**SUBMISSION**

**BEECROFT-CHELTENHAM CIVIC TRUST**

**North West Rail Link Project**

**Environmental Impact Statement No 2**

**BOC** PROPOSED ALTERNATIVE ROAD ALIGNMENT  
TO PRESERVE PRISTINE BUSHLAND.

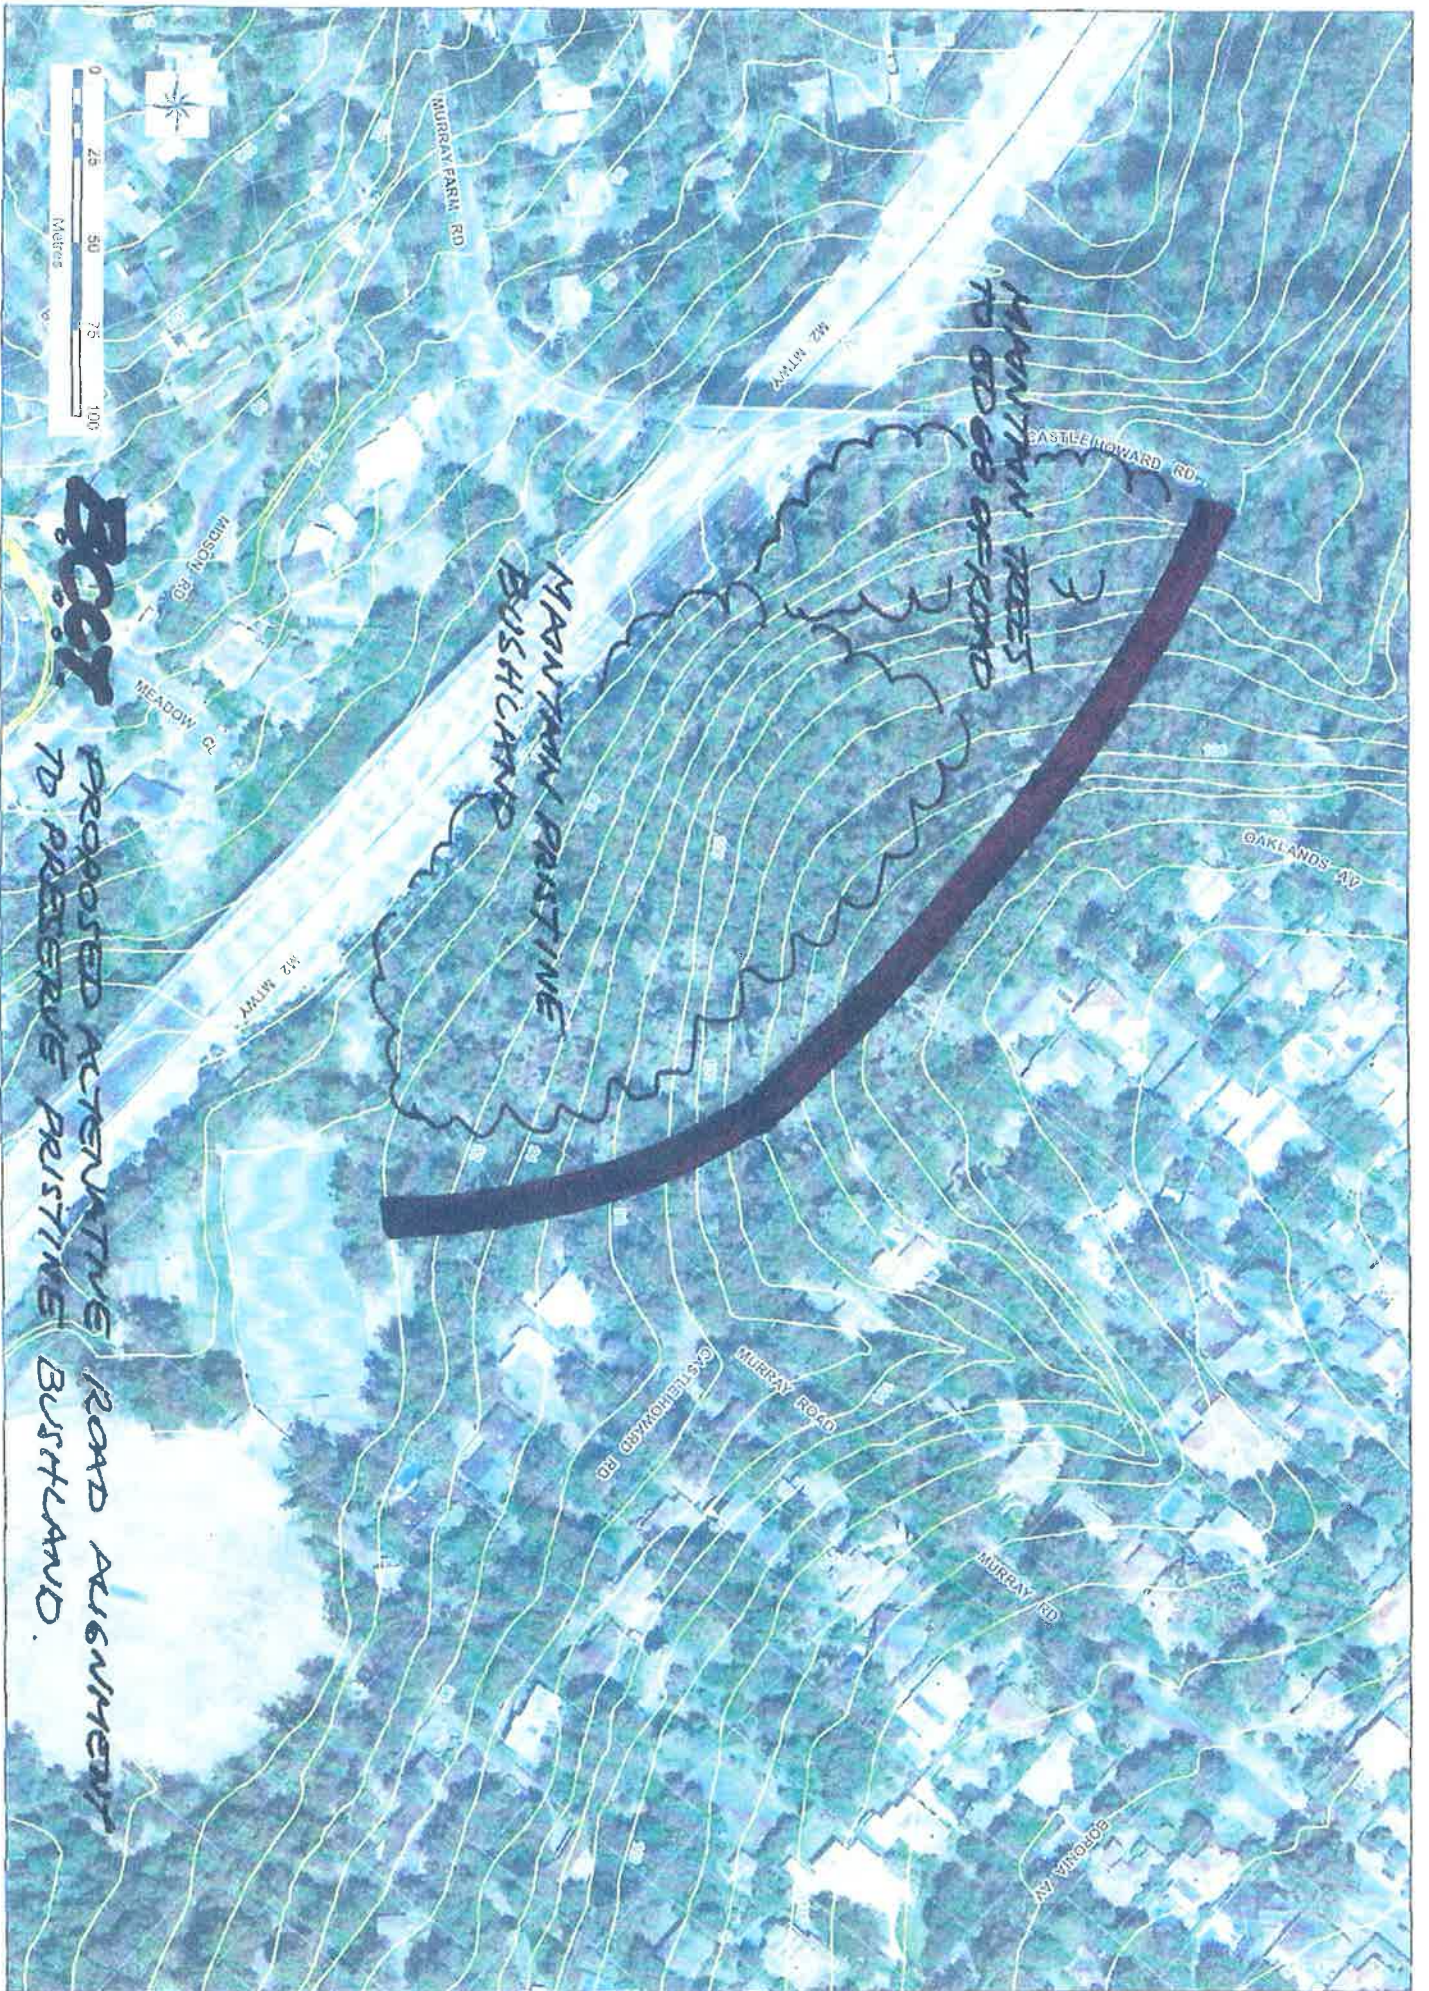
The Trust has been informed that the project team has been considering a possible alternative access road which is a single lane road, controlled by lights at each end, largely following the existing walking track. The road would be temporary, for use during construction only, to be removed on completion of work and the site regenerated. A plan of this route, based on the information available to the Trust and from a detailed site evaluation, is annexed to this submission.

The Trust sees this as a preferable alternative. However, it appears from comments made at a site meeting on 29 November 2012 between Trust committee members and North West Rail Link ("NWRL") representatives that it is unlikely to proceed because the proposed road, with two lanes, has already been approved as part of the process under EIS1, the alternative site is outside the approved area, and it would take an additional 3-4 months to reassess the changes and secure fresh approvals. The Trust submits that these reasons are not sufficient justification for dismissing the alternative. The Trust submits that:

- The degree of disturbance along the alternative route along the line of the walking track will be significantly less than the proposed route along the M2 fenceline;

- It will be easier (and therefore less costly) and environmentally better to regenerate along the alternative route, because the terrain is flatter and more even, with deeper soils;

- A single lane road controlled by traffic lights is all that is needed to cope with construction traffic over the construction period;
- The amount of STIF likely to be affected by the alternative route could be substantially less than that which will be affected by the proposed route;

For these reasons the Trust submits that the existing approved location for a permanent road will not necessarily be the best location for a temporary road. The alternative offers a satisfactory outcome with reduced environmental impact, and deserves to be fully and properly assessed.
